## Reviewer 2

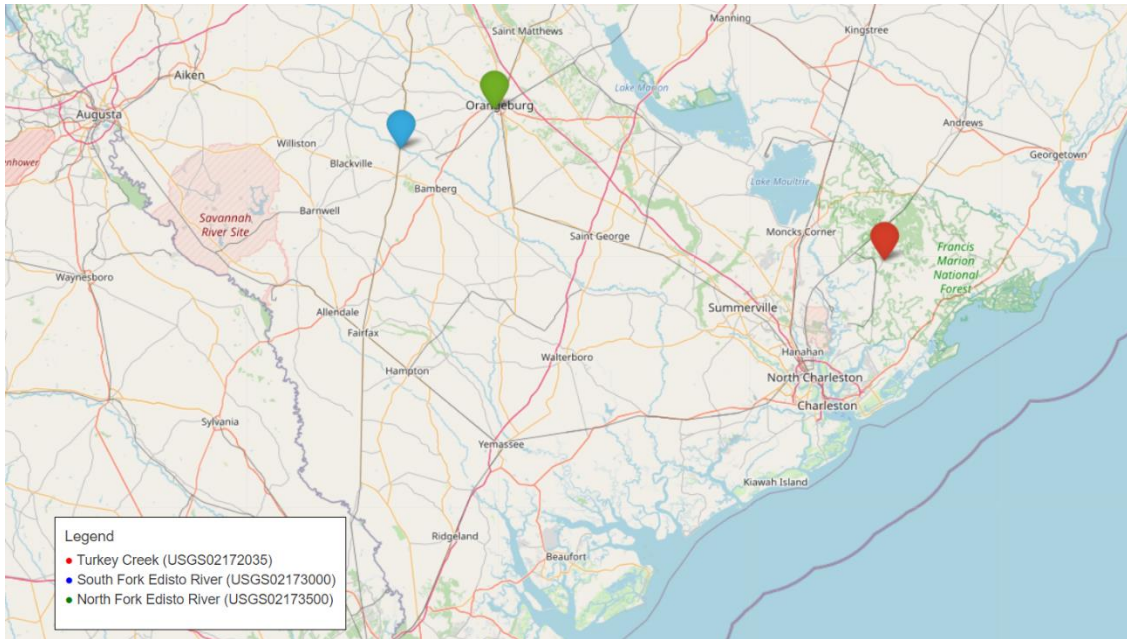
- Line 106-107: Figure 1, there is no indication of three USGS gauging stations. Legend is better to rename following the gauging station name e.g., Turkey Creek (USGS02172035), South Fork Edisto River (USGS02173000), and North Fork Edisto River (USGS02173500).

**Response:** Thank you for this direction. We have now revised this figure in the paper. See below.

### Step 1: Forecast Gauge Height

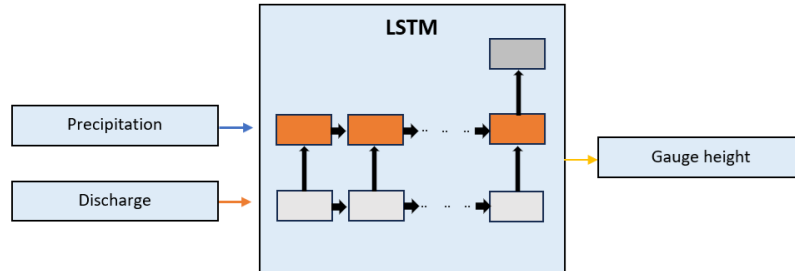
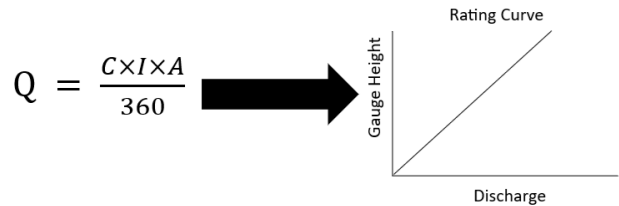
- Line 160: Equation should be well-presented (Figure 2) and consistent.

- Line 160: typo Gage or Gauge in Figure 2.

**Response:** Thank you. We fixed the equation and revised the figure to ensure consistency.

Response: Thank you for the comment. We corrected this in Figure 2. See below, please.
